**Beaver Valley Power Station
Unit Nos. 1 and 2**

**License Amendment Requests
302 and 173**

Extended Power Uprate

L-04-125

Reactor Coolant System Cooldown (up to 20°F/HR.)
Limitations Applicable for the First 1422 EFPY (TS 3.4.9.1)

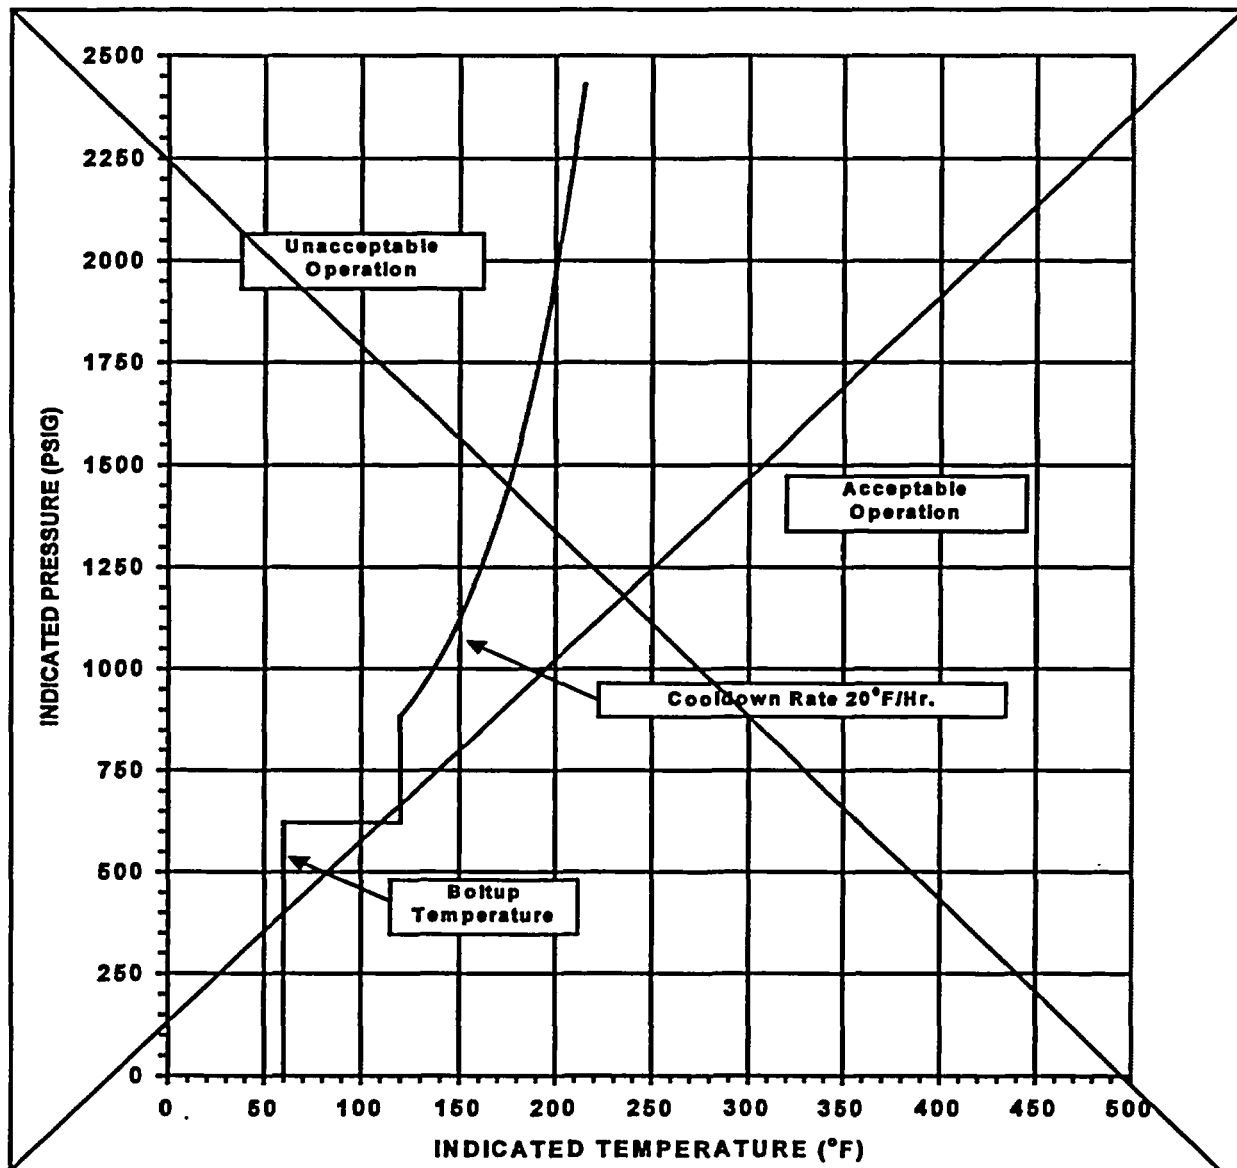
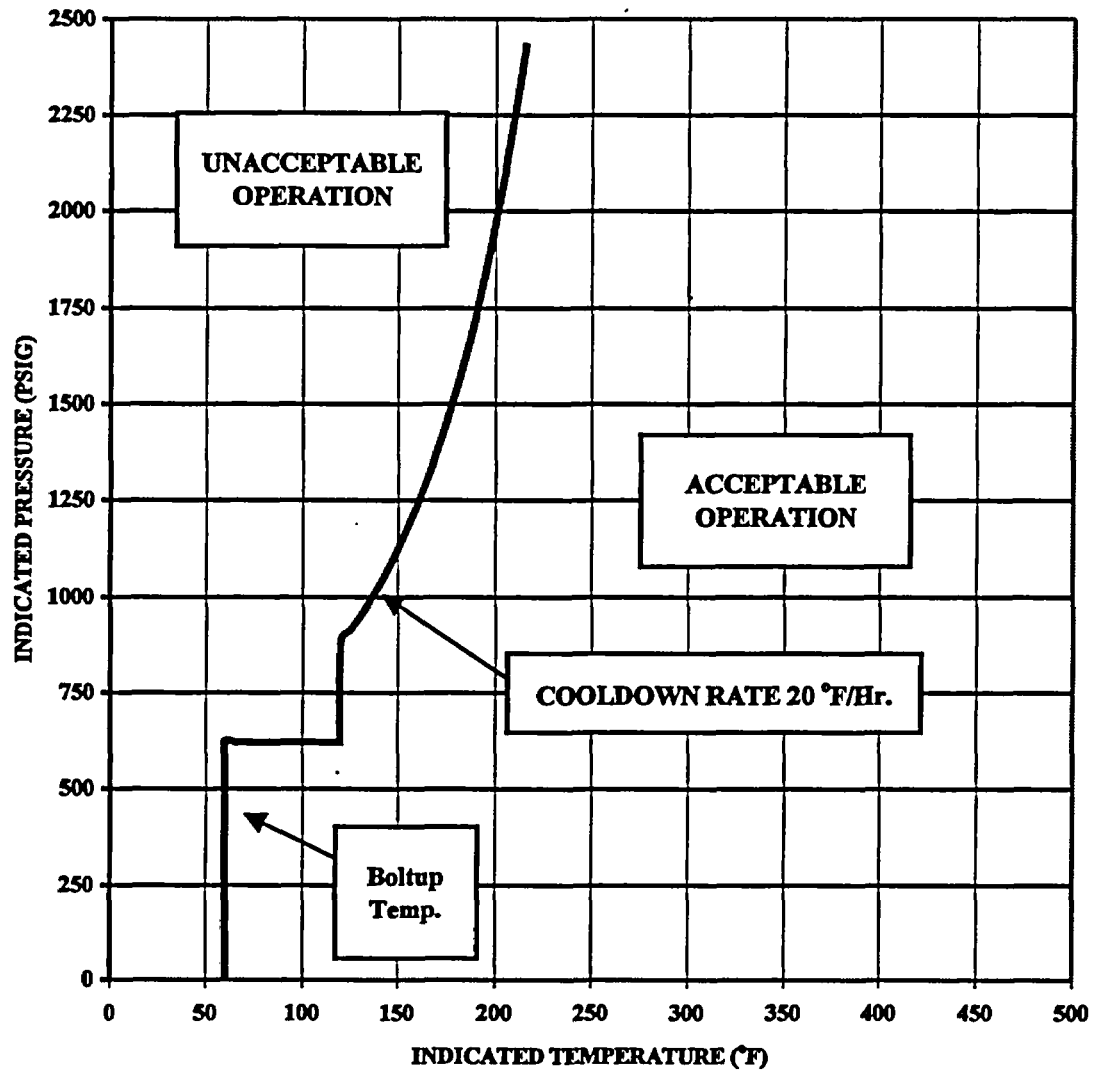
RT_{NDT} AFTER 1422 EFPY: 1/4T, 140°F
3/4T, 128, 129°F

CURVE APPLICABLE FOR COOLDOWN RATES UP TO 20°F/HR FOR THE SERVICE PERIOD UP TO 1422 EFPY.

Replace with
Insert C2-6.

Insert C2-6.

Reactor Coolant System Cooldown (up to 40°F/Hr.)
Limitations Applicable for the First 1422 EFPY (TS 3.4.9.1)

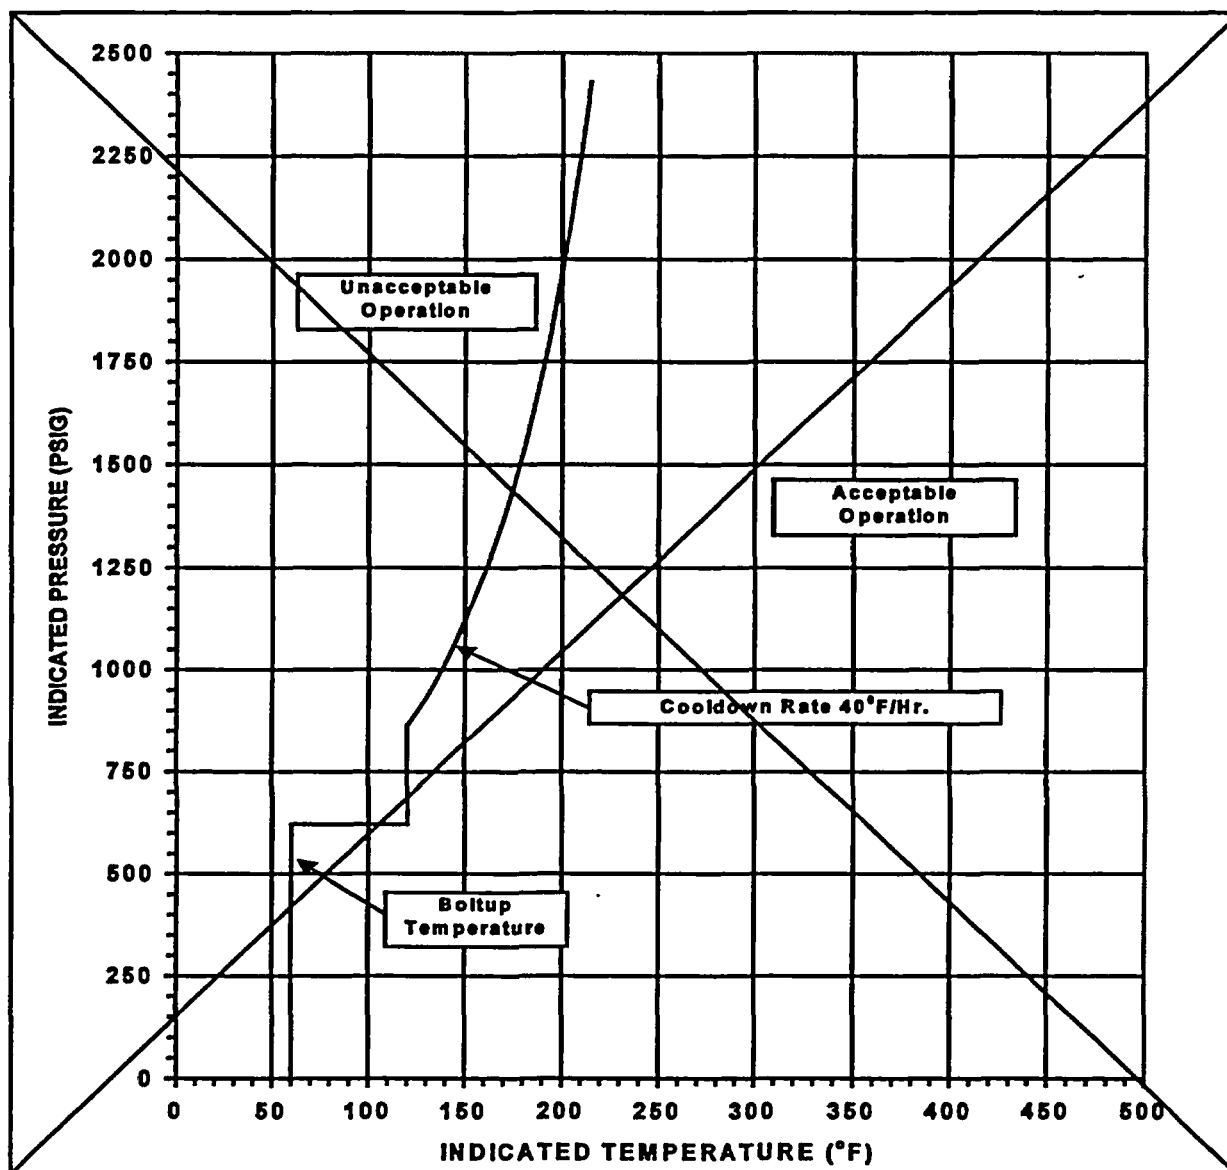
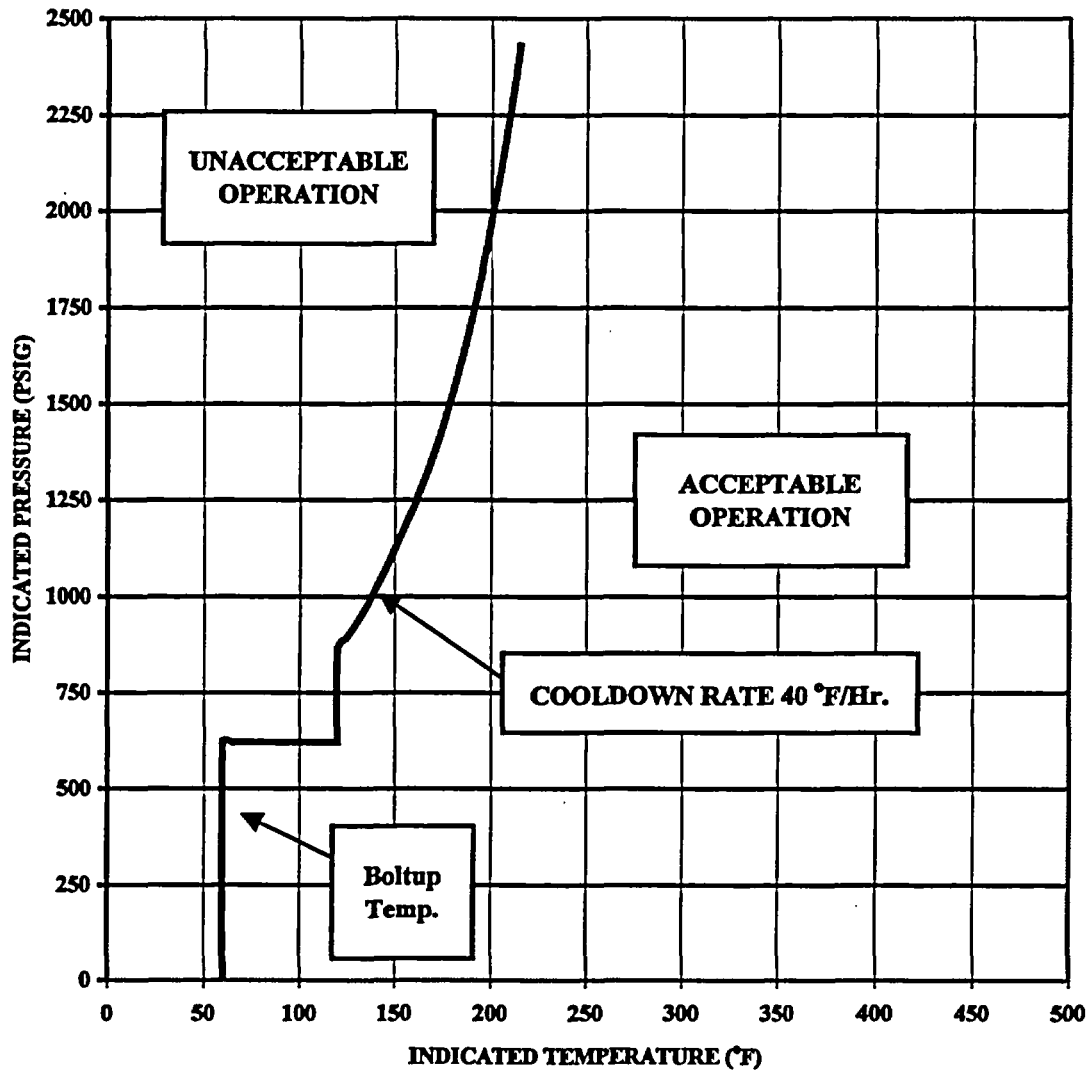
RT_{NDT} AFTER 1422 EFPY: 1/4T, 140°F
3/4T, 128129°F

CURVE APPLICABLE FOR COOLDOWN RATES UP TO 40°F/HR FOR THE SERVICE PERIOD UP TO 1422 EFPY.

Replace with
Insert C2-7.

Insert C2-7.

Figure 4.2-5
Reactor Coolant System Cooldown (up to 60°F/HR.)
Limitations Applicable for the First 1422 EFPY (TS 3.4.9.1)

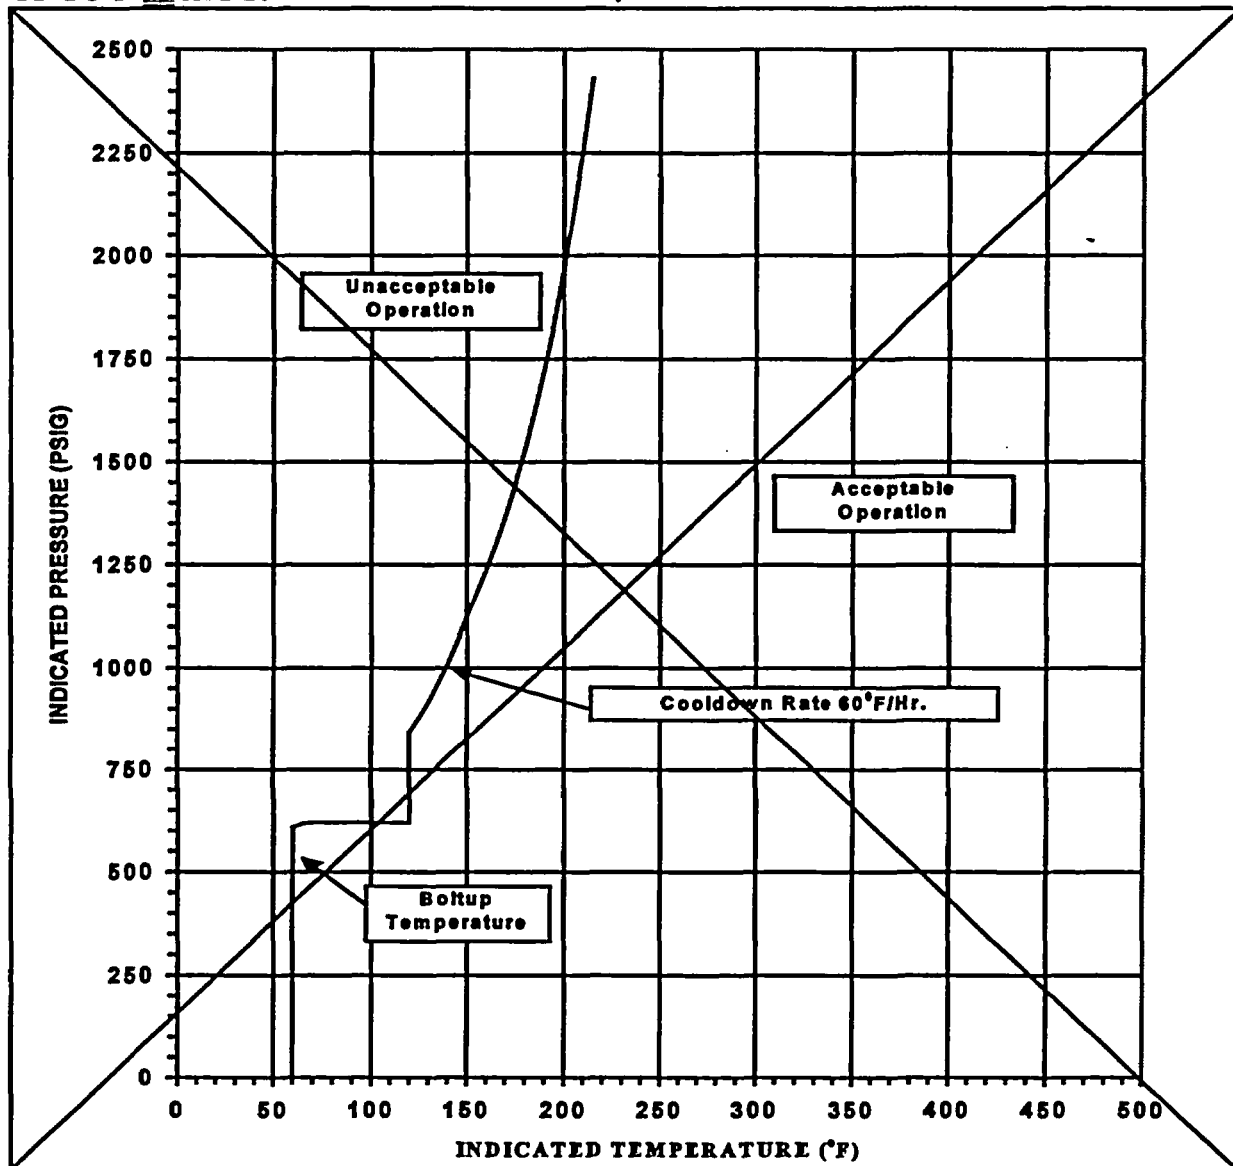
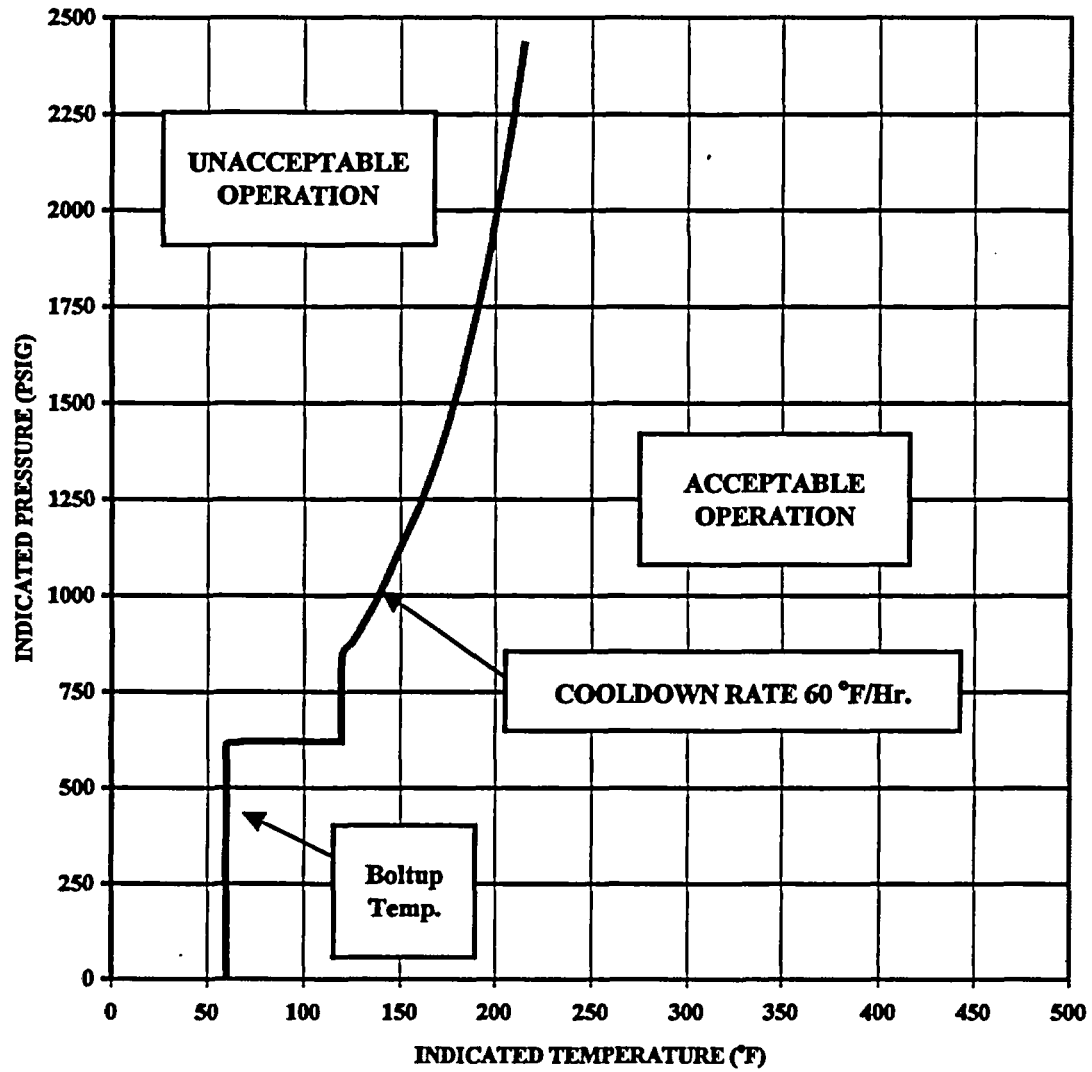
RT_{NDT} AFTER 1422 EFPY: 1/4T, 140°F
3/4T, 128129°F

CURVE APPLICABLE FOR COOLDOWN RATES UP TO 60°F/HR FOR THE SERVICE PERIOD UP TO 1422 EFPY.

Replace with
Insert C2-8.

Insert C2-8.

Reactor Coolant System Cooldown (up to 100°F/ Hr.)
Limitations Applicable for the First 1422 EFY (TS 3.4.9.1)

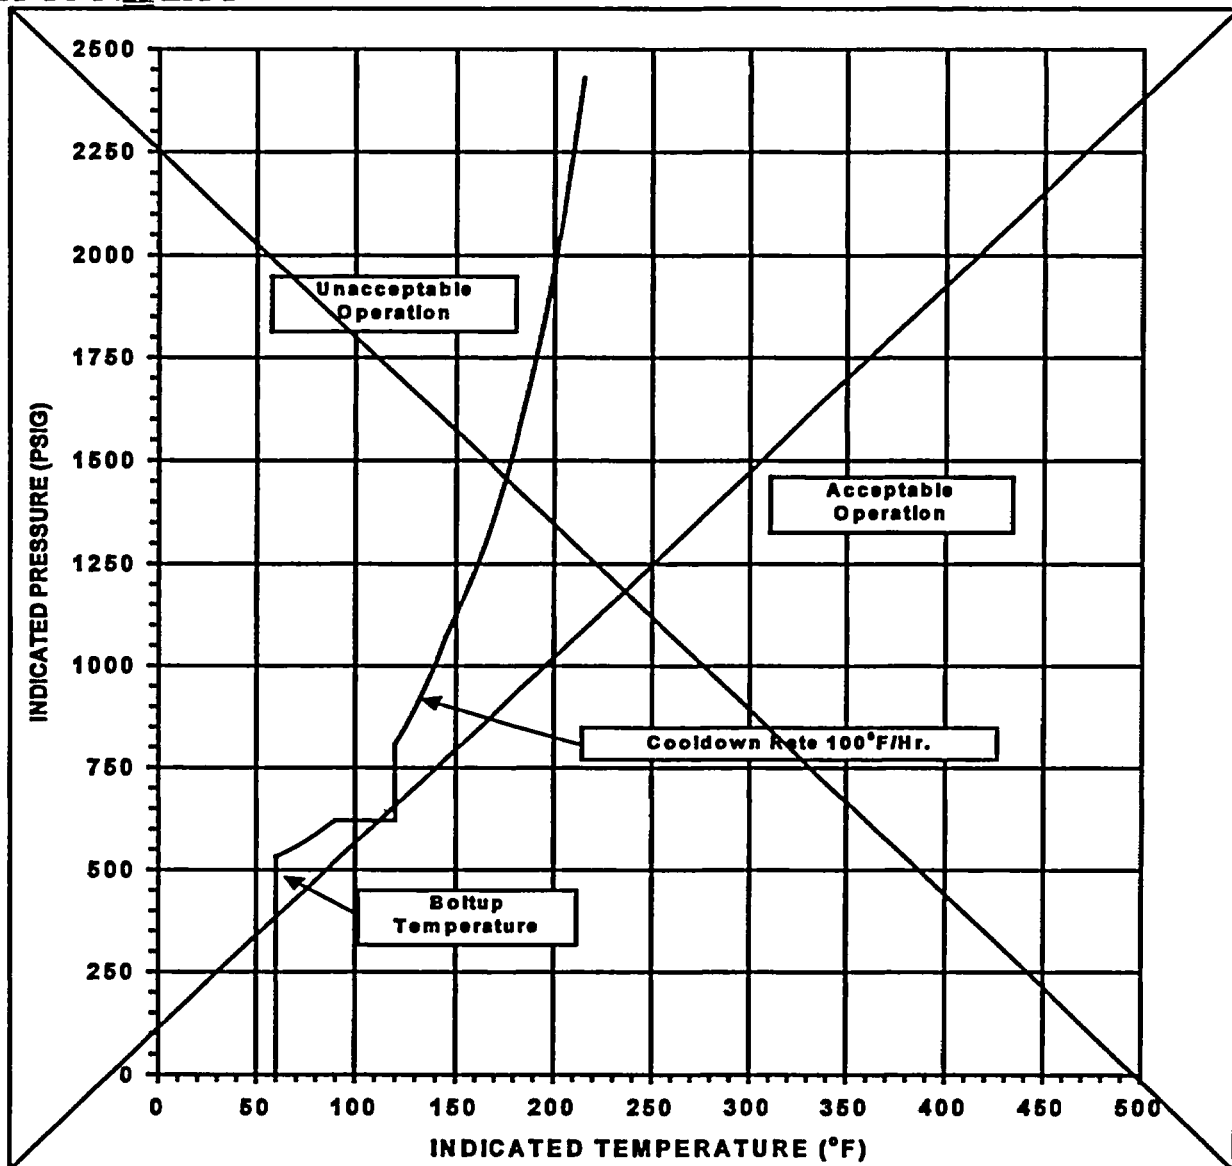
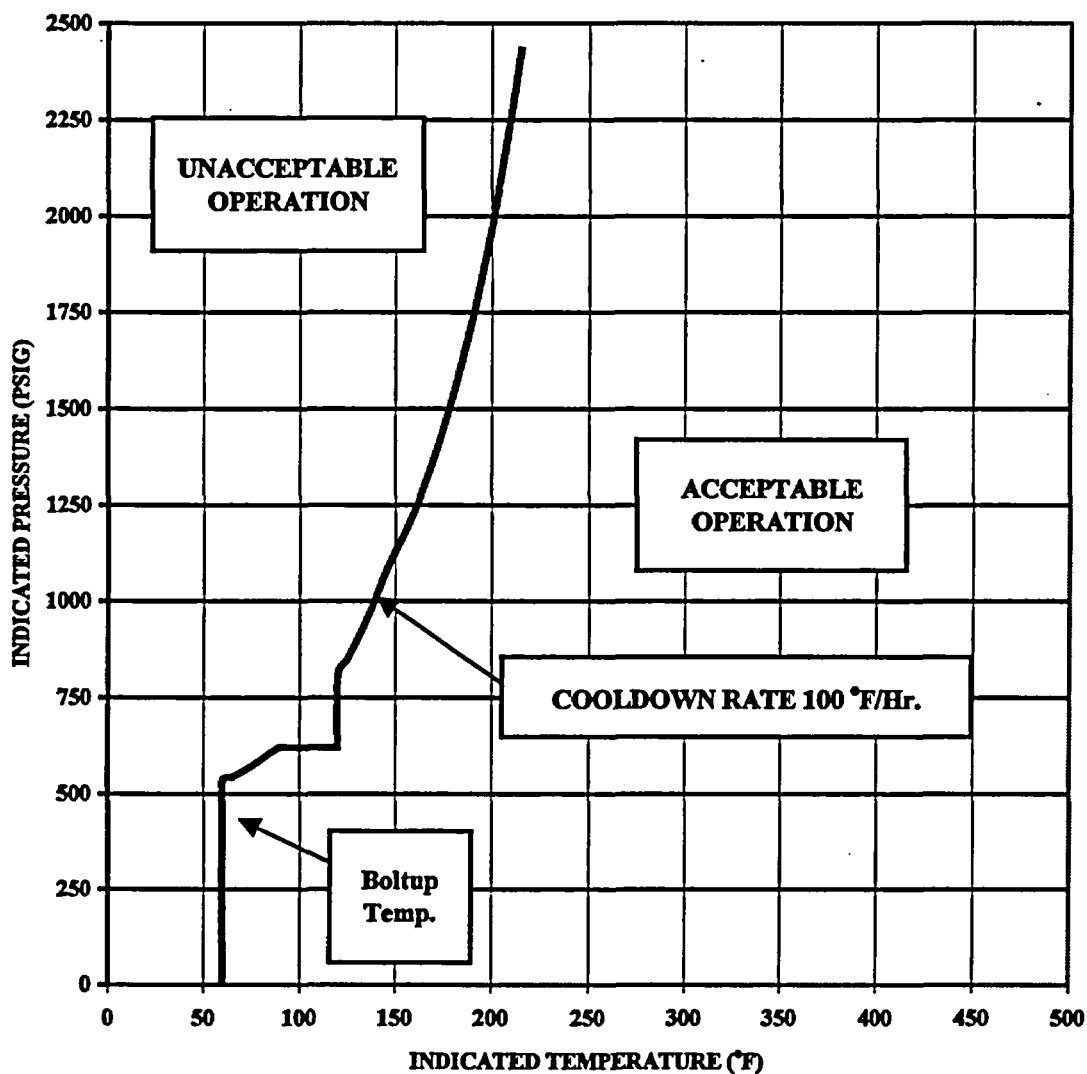
3/4T, 128129°F

CURVE APPLICABLE FOR COOLDOWN RATES UP TO 100°F/HR FOR THE SERVICE PERIOD UP TO 1422 EFY

Replace with
Insert C2-9.

Insert C2-9.
